Reference: **ACCESS CONSULTANCY
DEVELOPMENT APPLICATION
1 BATHURST STREET LIVERPOOL 2170**

ACCESS REPORT DEVELOPMENT APPLICATION

RESIDENTIAL DEVELOPMENT 1-5 BATHURST STREET LIVERPOOL NSW 2170

Document Type: Access Report

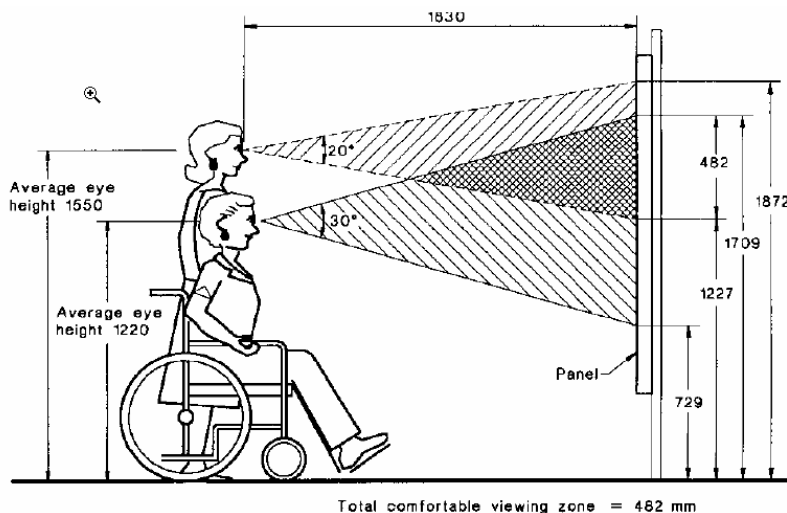
The detailing of the letterboxes will need to comply with the rules of Australia Post and AS4253:1994 – Mailboxes. Details of the mailboxes will need to be revised from that as detailed. Specific reference is directed to mounting position of mailboxes above the floor.

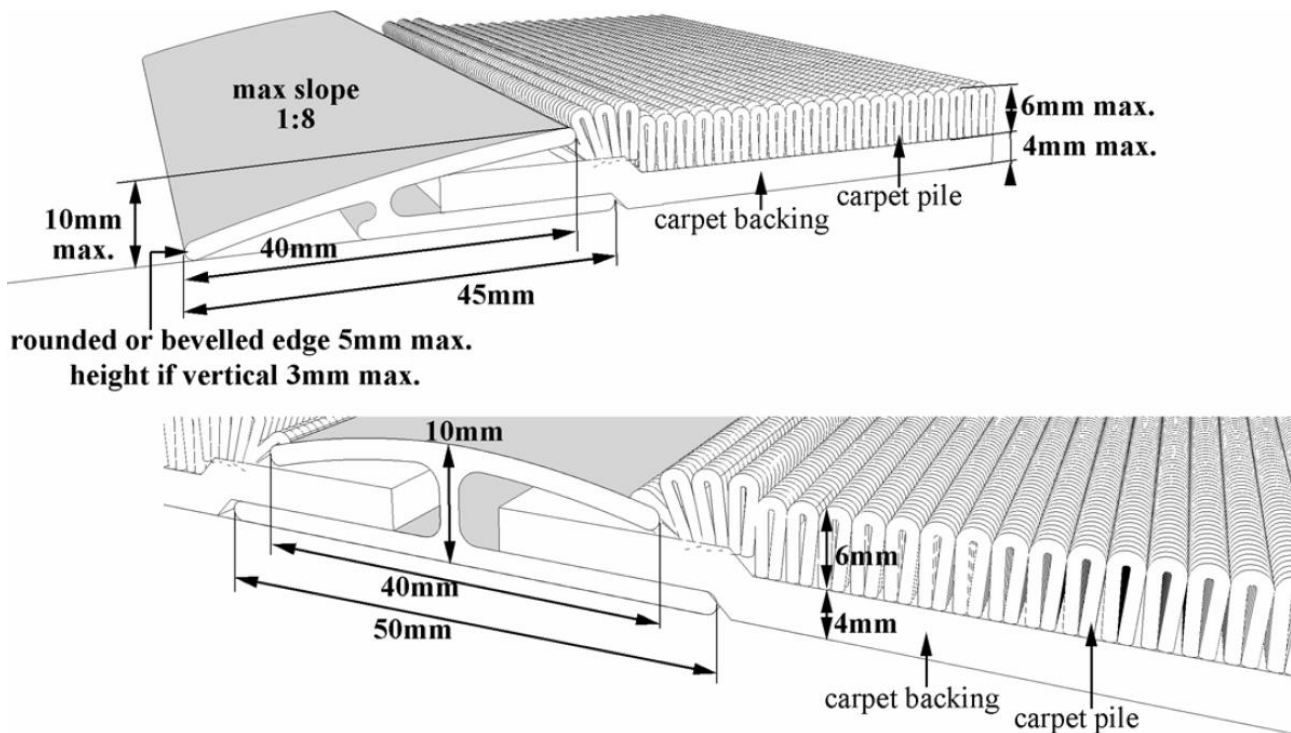
The plans provided indicate laundry cupboard arrangements. When the doors to the laundries are in the open position a 1500 x 800mm circulation zone is available in front of the fixtures

PRE ADAPTATION PLAN - UNIT G.10
Scale 1:50

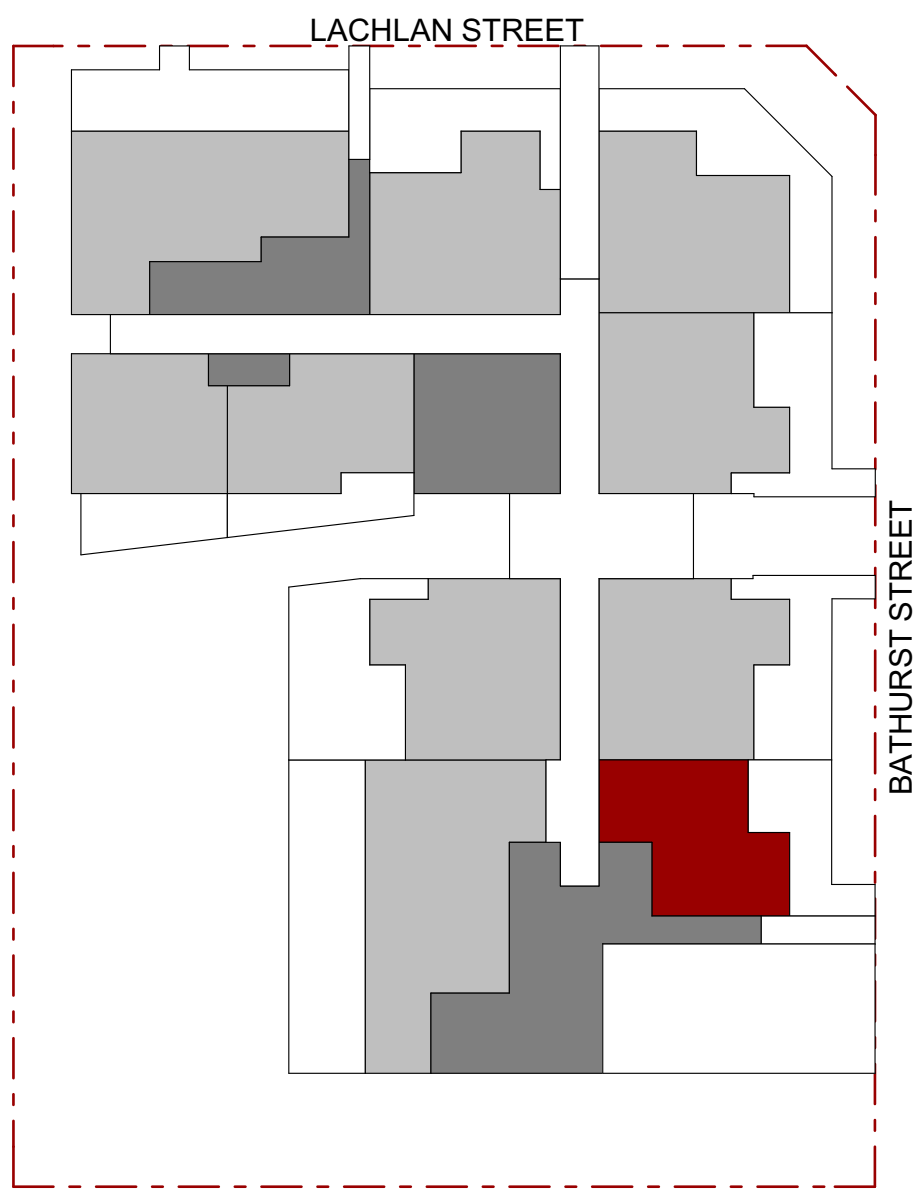
Post adaptation drawings will need to be prepared indicating compliance with this provision.
